**GULF STATES UTILITIES COMPANY**

River Bend Station - Unit 1

Docket No. 50-458

### RESPONSE TO SER OPEN ITEMS (10) AND (16) AND CONFIRMATORY ITEM (51):

SKETCH 8.3-12-6

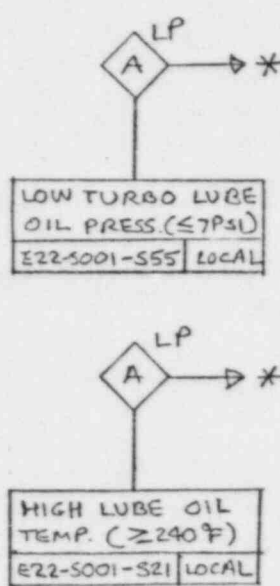
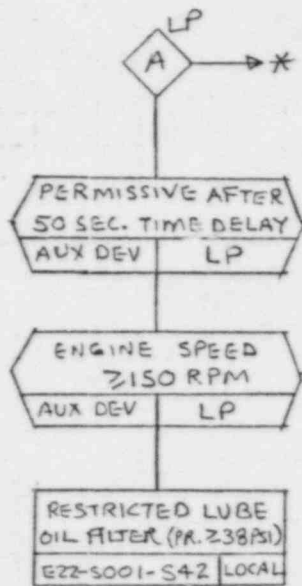
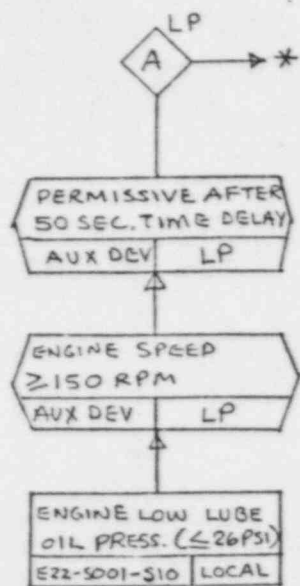
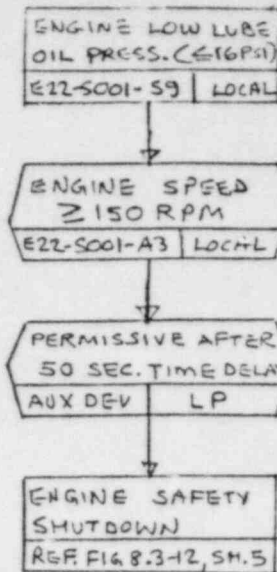
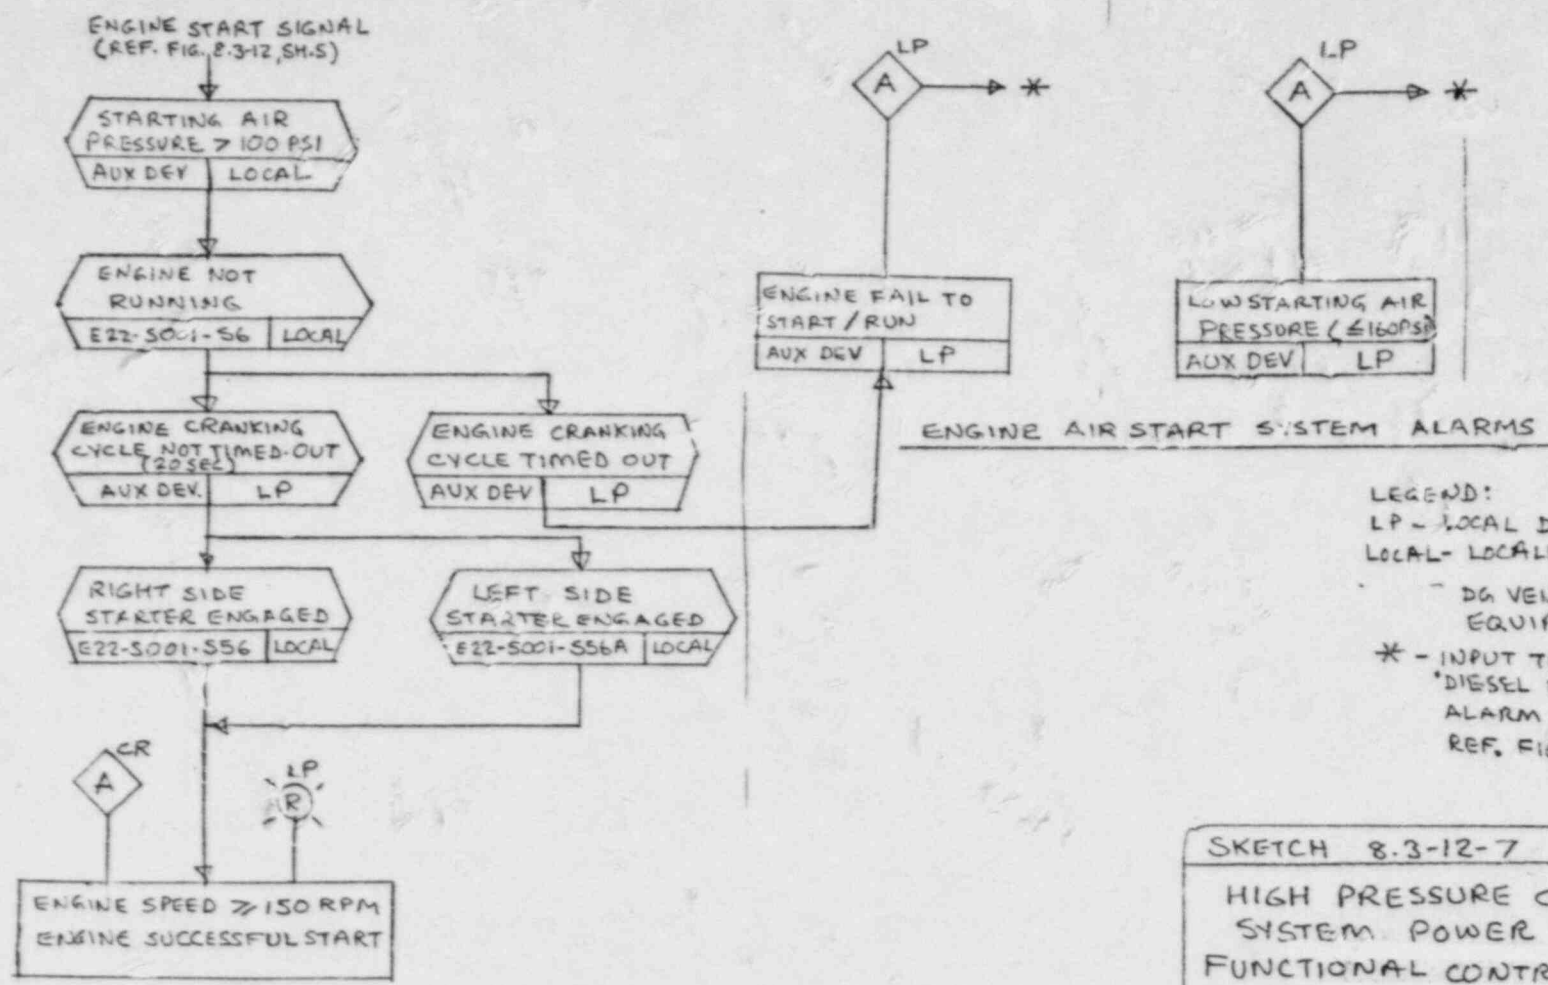
Additional information for the HPCS diesel generator auxiliary systems controls, alarms and instrumentation is provided in Enclosure 3. These drawings will be incorporated into the FSAR in a future amendment.

NOTE TO SWEC/GSU: THIS SKETCH DOES NOT INCLUDE MI-9644 MODIFICATION. AE/GSU TO MODIFY AS REQUIRED UPON IMPLEMENTATION.

NUCLEAR SAFETY RELATED ON CAT 1 & 11	
LOGIC DIAGRAM	
AIR START-UP STANDBY DIESEL GENERATOR	
REVER BEND STATION - UNIT 1	
GULF STATES UTILITIES COMPANY	
HYDRA & WRIGHT ENGINEERING CORPORATION	
12210-LSK-12-4A

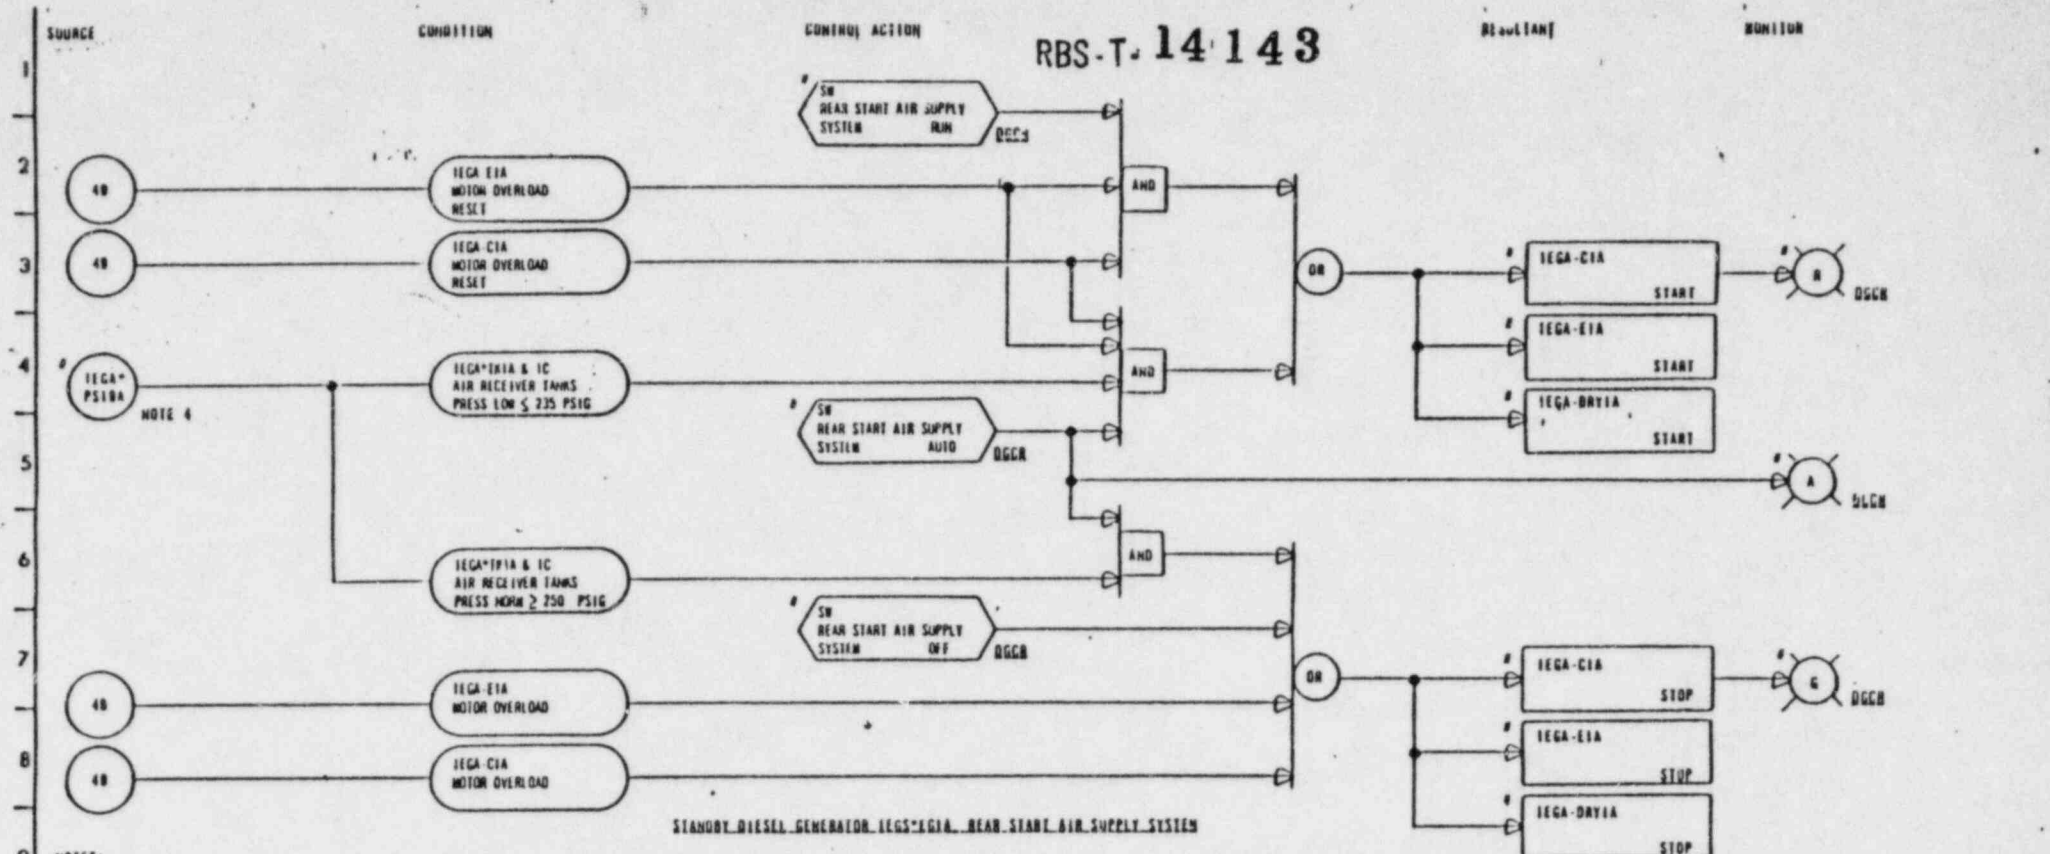
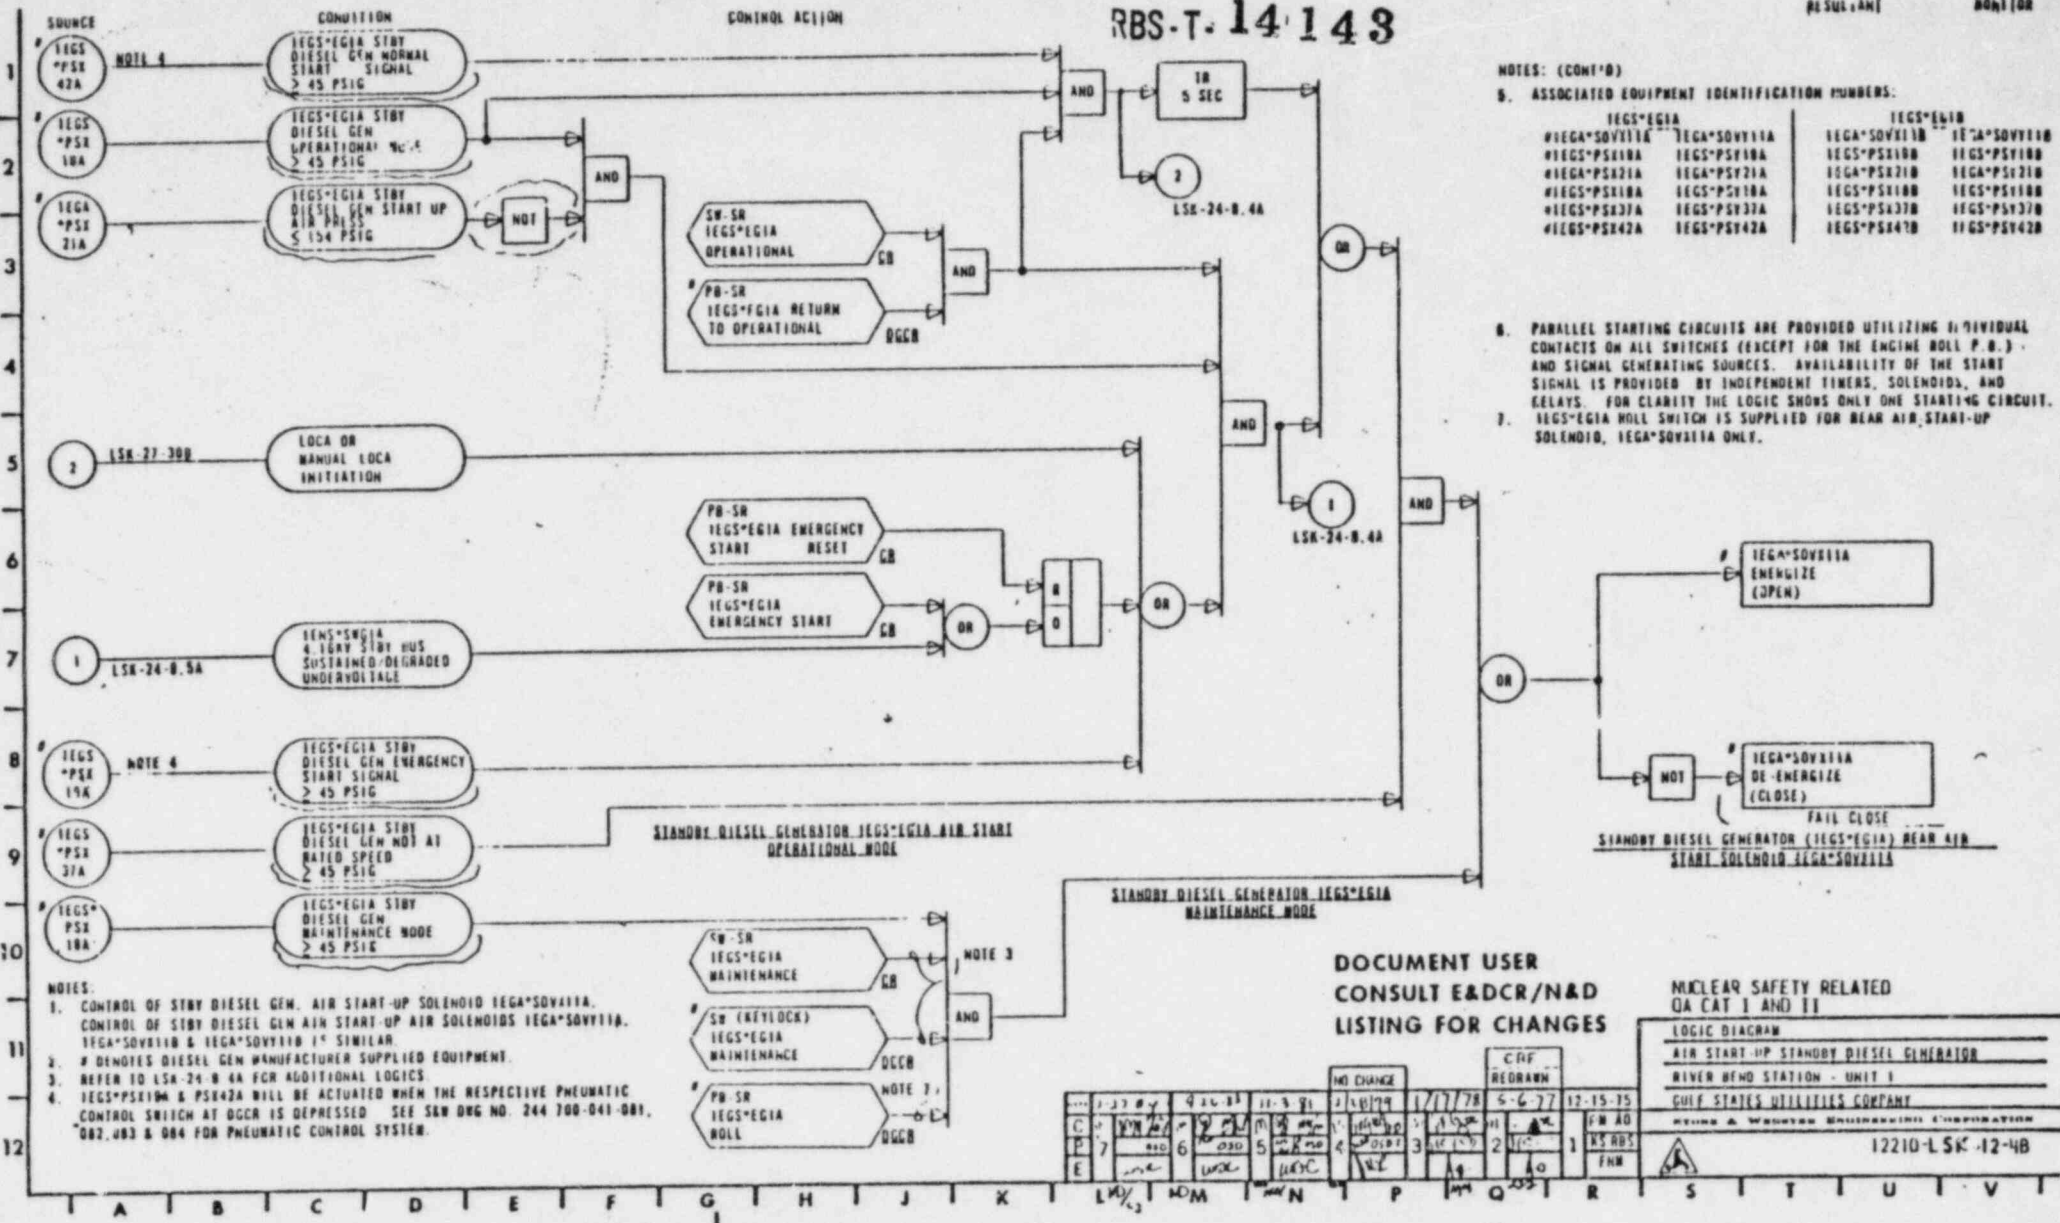
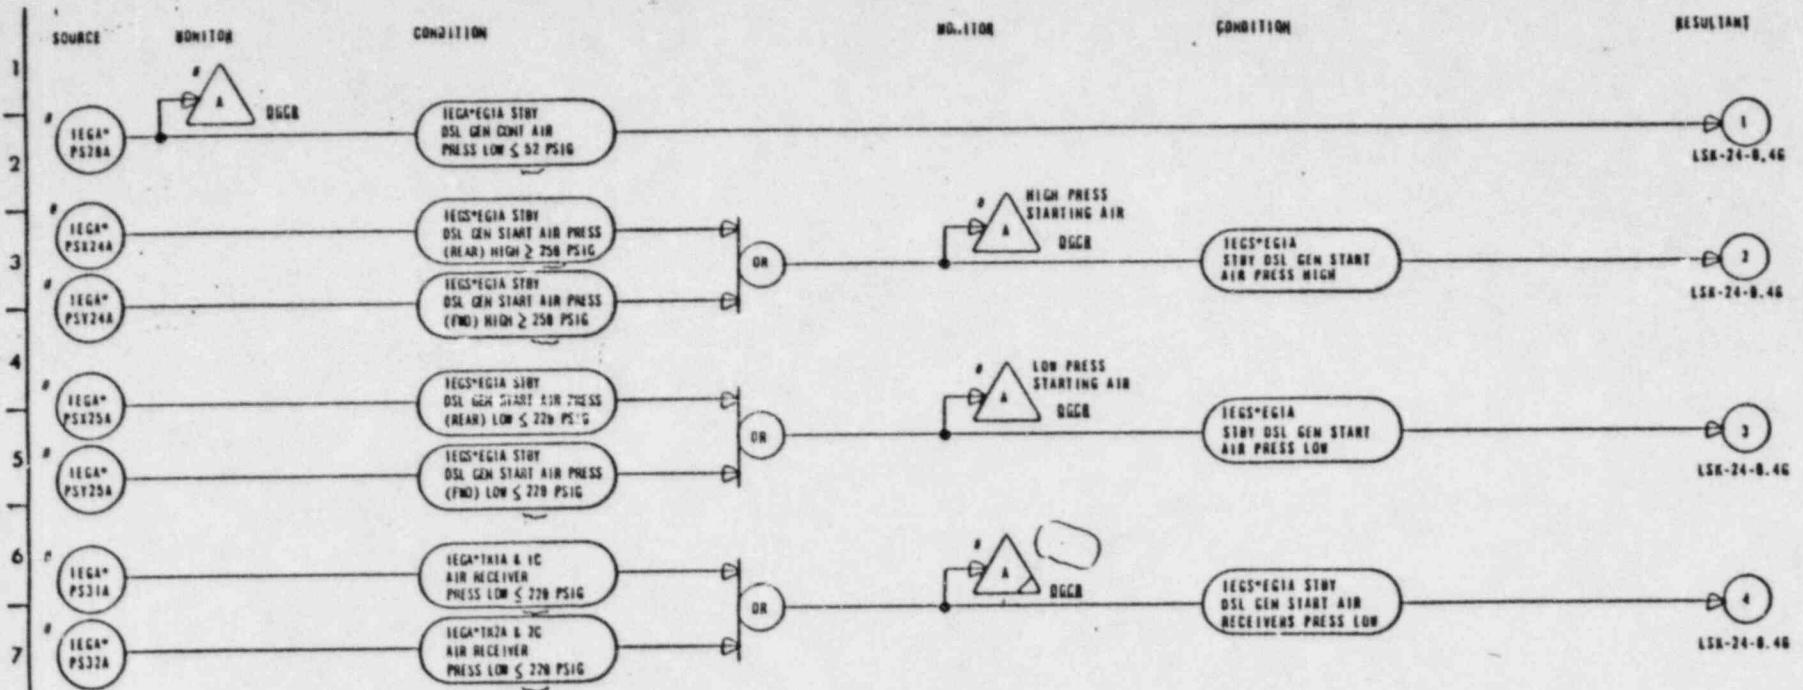
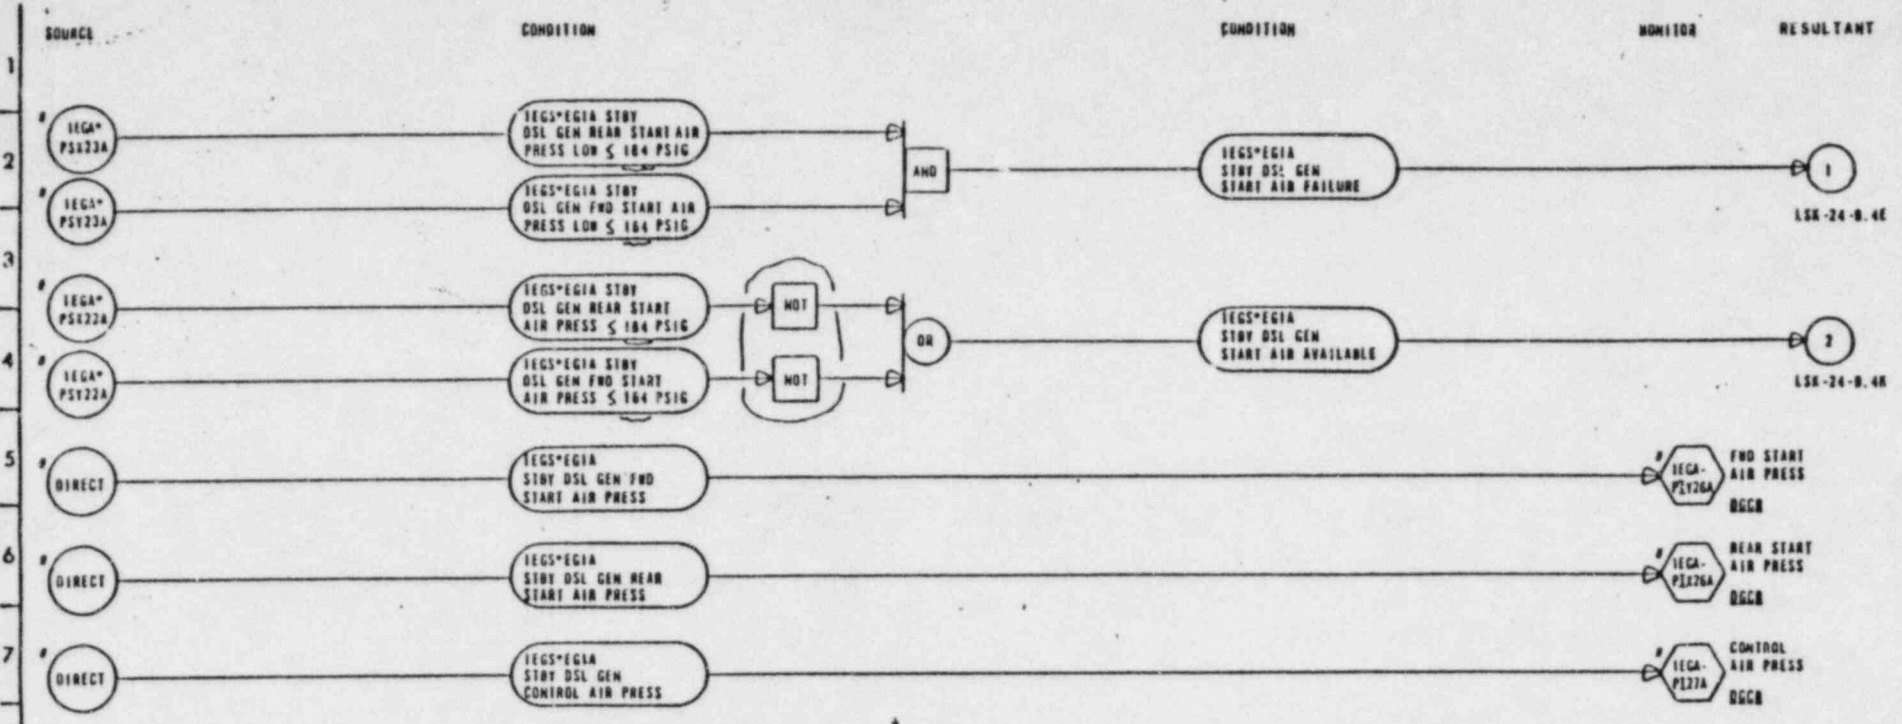
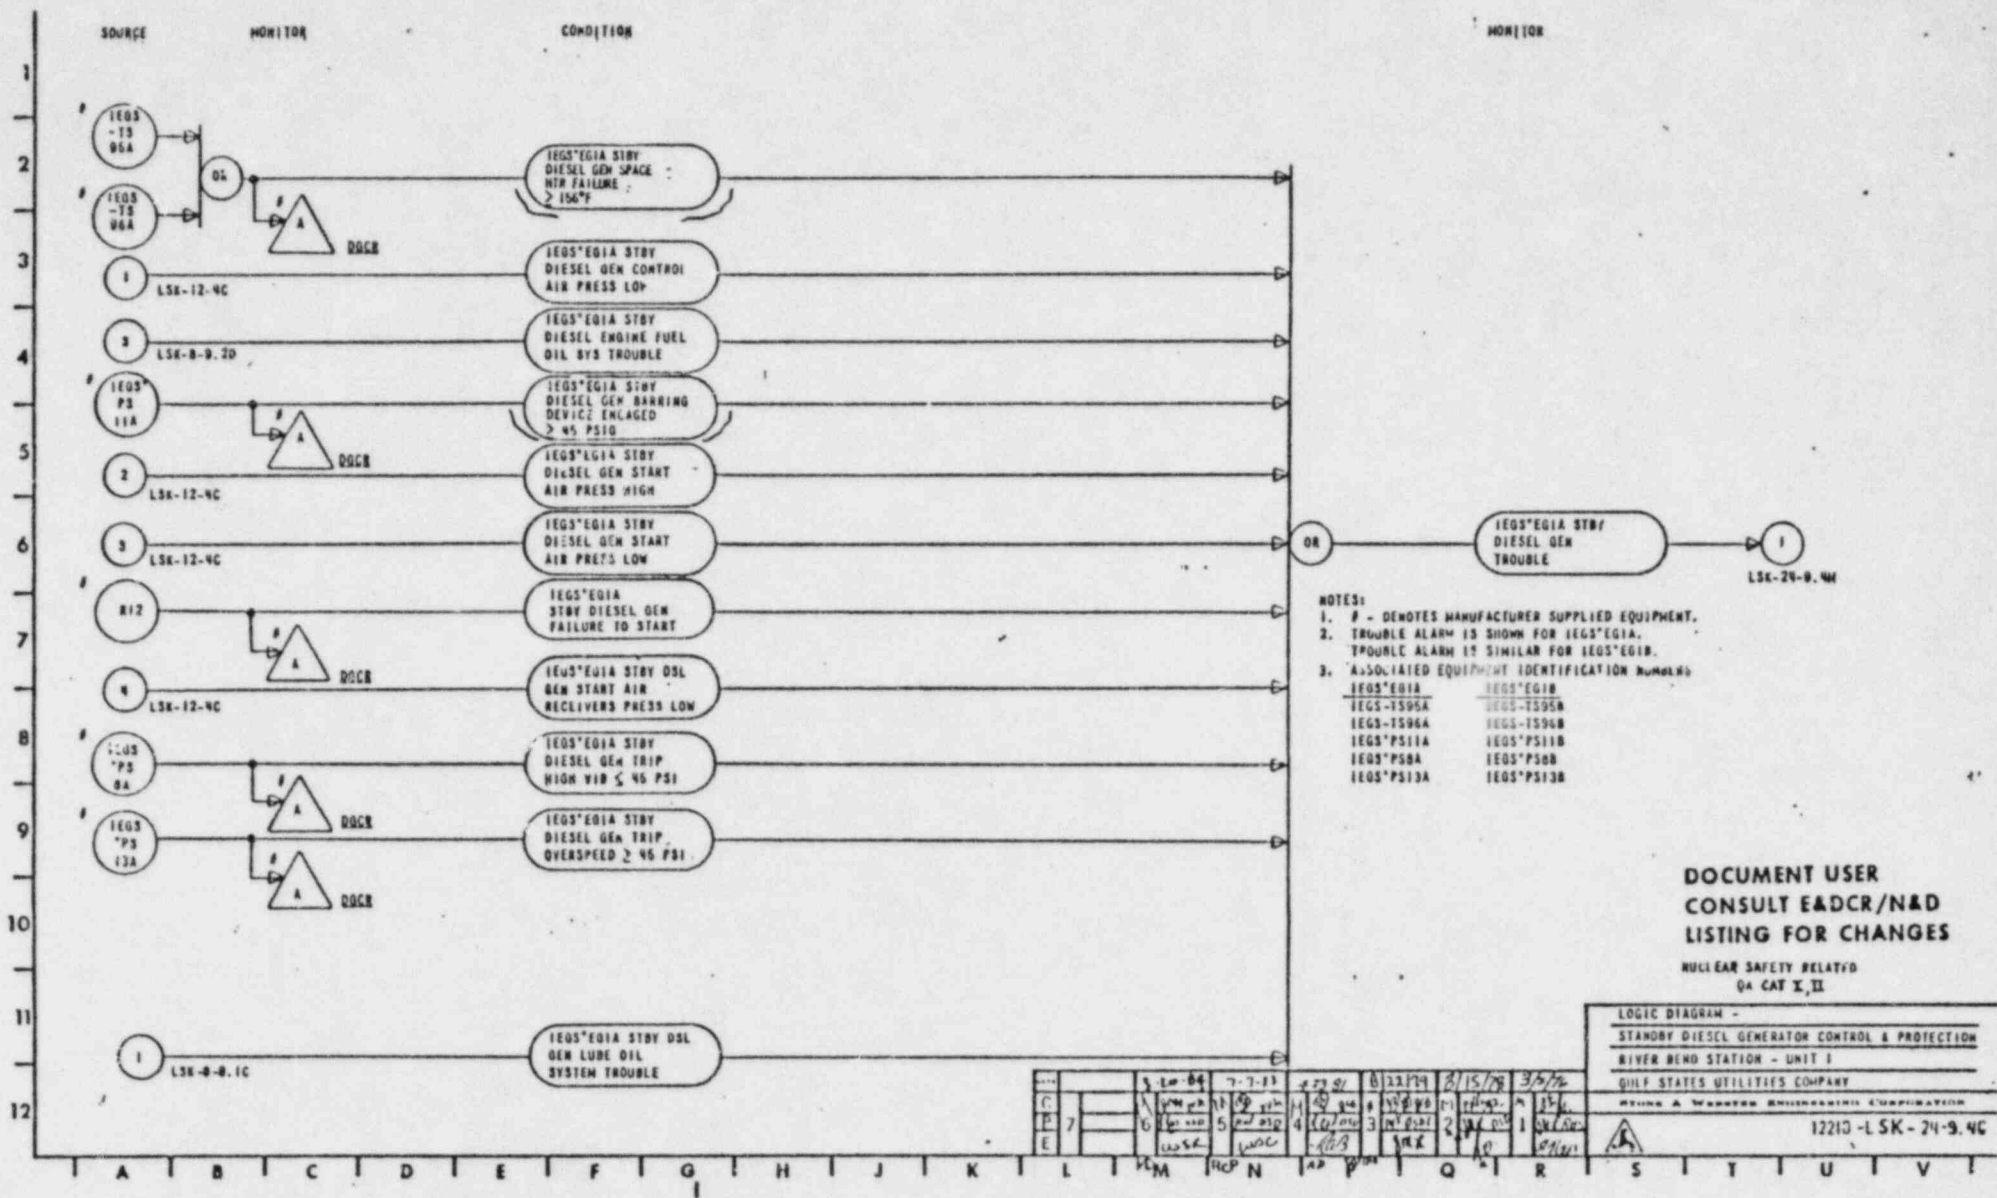
VIII DGSS I&C DRAWINGS

The standby diesel generator air start system instrumentation and controls diagram is provided in Enclosure 8. These drawings will be incorporated into the FSAR in a future amendment.
